CONSTRUCTION SUMMARY

Red Oaks on Bayview - Trinimont Developments Inc.

REG. PLAN# HOUSE TYPE 65M-4737 Elm 1 Elev B

121/1

MAIN LEVEL

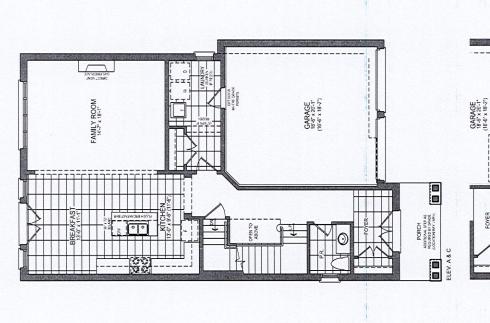
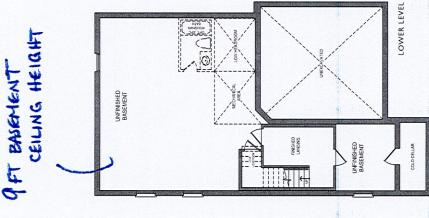
PORTICO
ADDITIONAL STEP AS
REQUESED BY CRADE
(LOCATION MAY (ART)
